YEAR/MODEL	Date Of Issue	Bulletin Number	Service Campaign
<b>2010.5-11.5 Balance Vehicles</b>	15NOV2011	<b>501331</b>	<b>FSA</b>

Vehicle quits on road will not restart, blown AZD under hood F028 fuse. Add fused overlay harness and inspect operation of low temp fans

Low temp radiator fans seize causing the fuse to blow that powers the VCU

### Harness Installation:

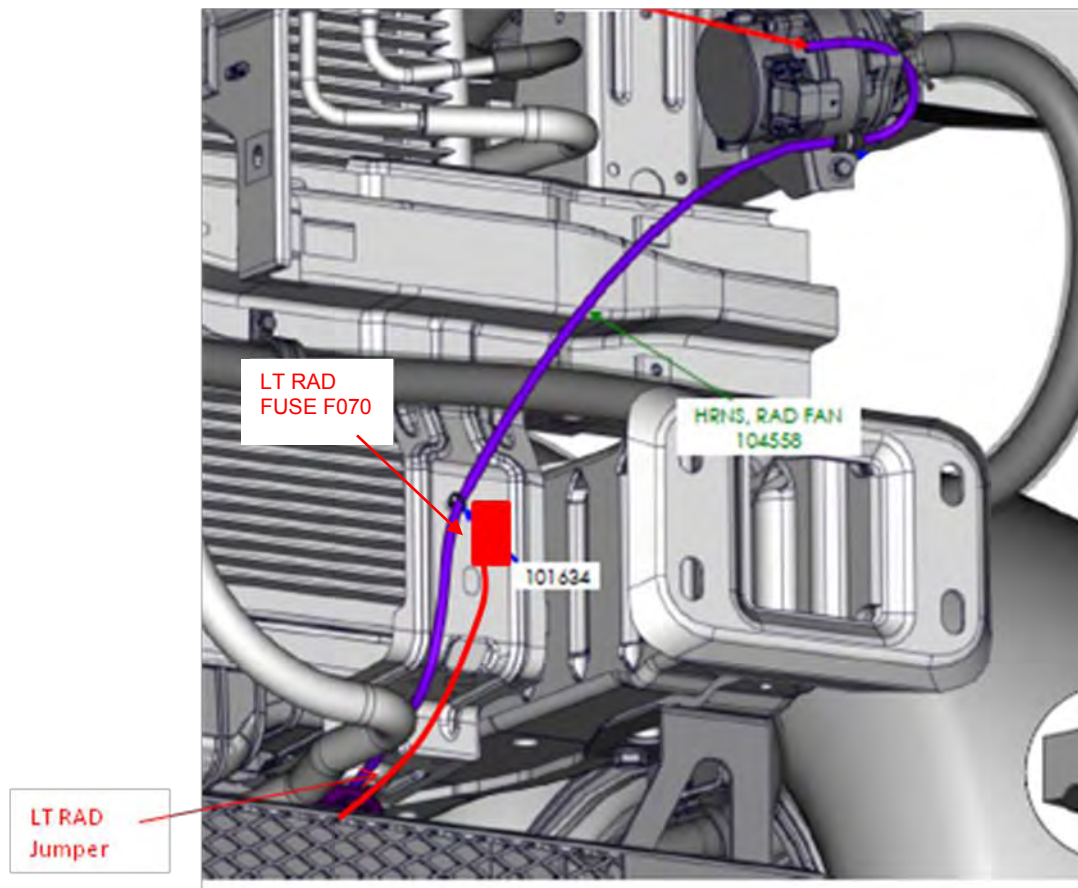
1. Disconnect C414S (Rad Fan Harness) from C414P (Thermal Switch)
2. Connect C414S to C414AP (LT Rad Jumper)
3. Connect C414P to C414AS (LT Rad Jumper)
4. Secure LT Rad Jumper to existing harness branches
5. Route branch F070 forward in vehicle following the existing wiring to the LT Pump

6. Remove fir tree from Ford Chassis in area shown above.
7. Secure F070 to Ford frame with fir tree (101634)
8. Secure LT Pump branch with tie strap on same fir tree

**Fuse and Label Installation:**

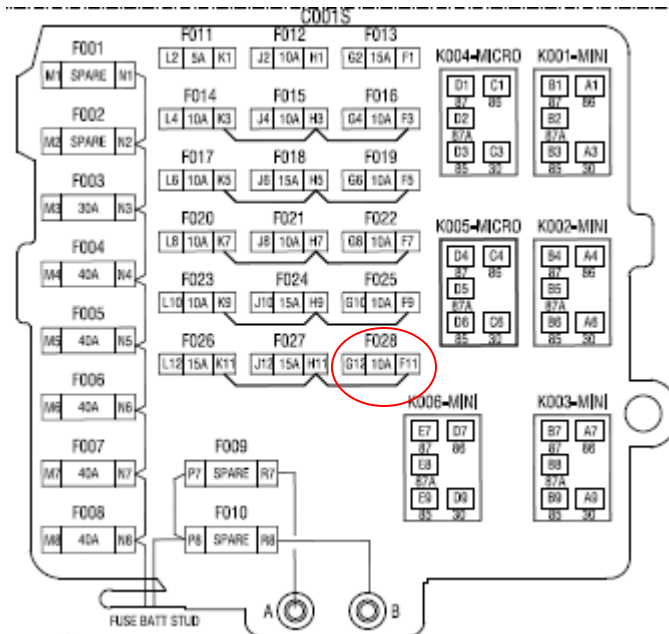
1. Remove 10A fuse in the F028 location from PDB on Power Dist Harness
2. Install 25A fuse in the F028
3. Remove Fuse Label 104567-C from cover of PDB
4. Install Fuse Label 104567-D in cover of PDB
